INDESIT company

R23IT

R24EU

Notices

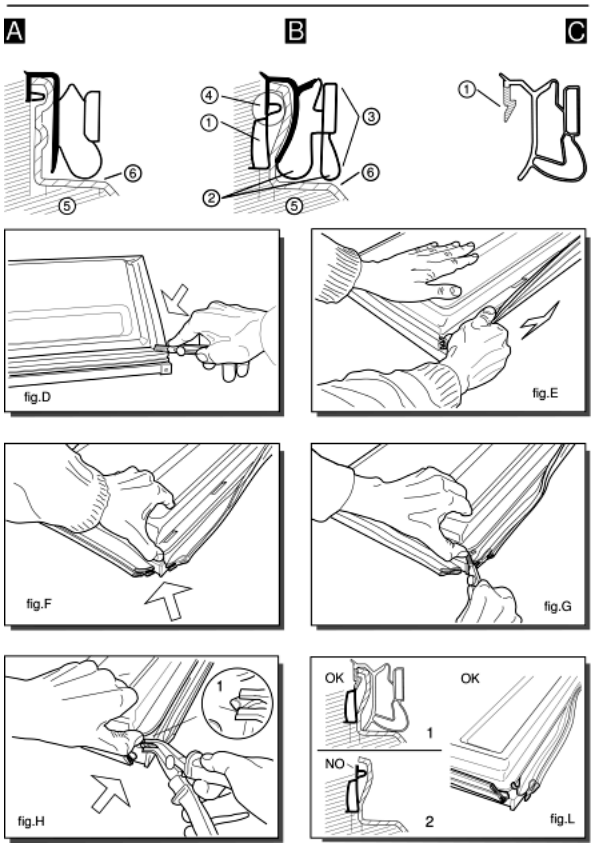
0514012: SEALS FOR DOORS FOAMED AS ONE PIECE

Various types of gaskets with different profile, as shown in figures (A) and (B), are used to fix the door (fig. A-5; B-5) and the inner door (fig. A-6; B-6) on the block foamed doors of combined freezers and refrigerators.
---Ilpea profile 245; 179; 412 (fig.A)
---Ilpea profile 287 (fig.B)
When replacing gaskets with profiles 245; 179; 412 these are fixed with screws (2 per corner) to the door.
Gaskets with profile 287 can not be used as spare parts but are designed to house the Ilpea type 900 gaskets (see figure C).
When replacing the gasket (287), once it is removed you will find a pocket (fig. B-1) between the door and inner door.
The rigid tooth (fig.C-1) of the gasket (900) is inserted inside between the pocket and the inner door, doing away with the need for screws.
Gasket with profile 287 is easy to identify since it has an exterior double edge (fig.B-2) which acts as a cushion when the door is closed.

To replace this gasket, follow these steps:
---Dismount the door and cut the four corners of the gasket along the joint (fig.D);
---lift the gasket and pull it carefully along its full length without tearing it (fig.E).
The purpose here is to detach the inner door slightly from the foam along the exterior edge for a depth equal to that of the gasket (fig.B-3);
---lift the corner of the inner door slightly, prising it up with your thumb (fig.F). Do not use a tool which might break the inner door;
---continue cutting the gasket inside the inner door for about 6 mm (fig.G);
---push in the tip of the pliers (type USAG N131) and pull outwards until you see the top edge of the pocket (fig. B-4) which is empty (fig.H-1);
---if you carry out this operation correctly (fig.L) you will be able to pull off the top edge of the pocket for the full length of the door.
If the gasket tears before the top edge (fig. L-2) you should repeat this operation from the other corner of the door.

---once the gasket (287), has been removed the space above the pocket (fig. L-1) can house the rigid tooth (fig. C-1) of the gasket 900.
When you fit this gasket ensure that it lies flush against the edge for the full length of the door.
If the rigid tooth is difficult to fit, eliminate any residues of foam between the door and the inner door in the gasket area.
fig.5131549A

N1025157FIG2

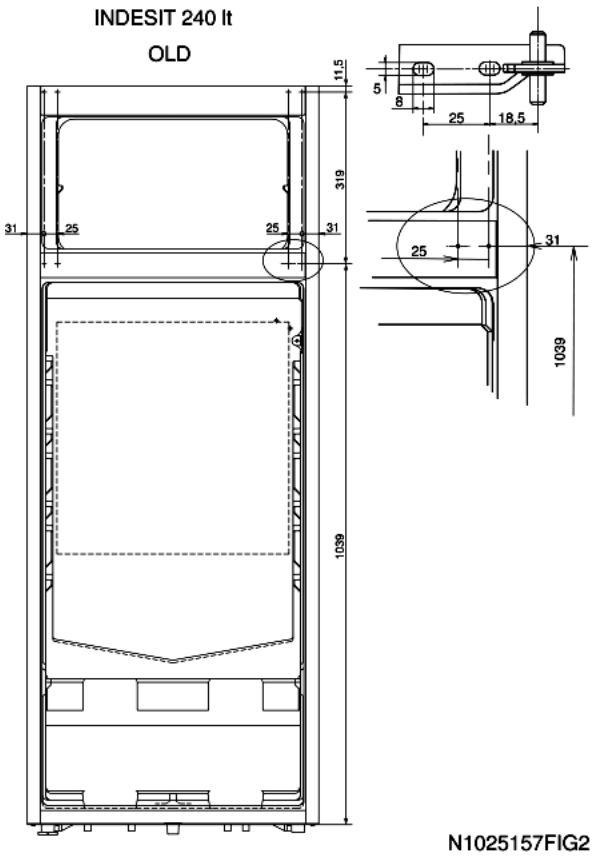
n1025157: New central hinge for Indesit-55 2-door 240 litre refrigerators (Carinaro)

From serial no. 60123.0001 the Carinaro factory has modified the body of the 240 litre refrigerator by introducing a new central hinge (see figure N1025058 Fig.1) secured to the side panel. In addition, the height of the refrigerator door has been reduced from

1030 to 1028 mm.
This hinge is still reversible but it cannot be fitted on premodification models, on which the hinge was attached to the central trim of the refrigerator cabinet (see figure N1025157fig2).
When changing the door opening from right to left, the new hinge does not need to be inverted like the previous one, just moved to the left side.
To fix the hinge drill a hole on the left side of the refrigerator cabinet (see figure N1025157fig3).

NB - 1028 mm high doors can be fitted to premodification models by using a 2 mm washer (028928 - 034618 - 036775) on the lower hinge.

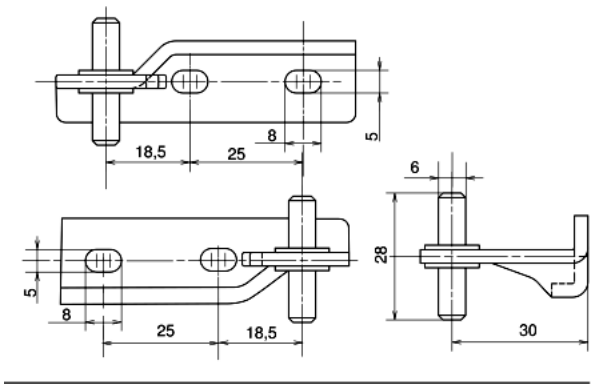
OLD 053838 - 053478 - 114624

NEW 141794 - 142760 - 142756
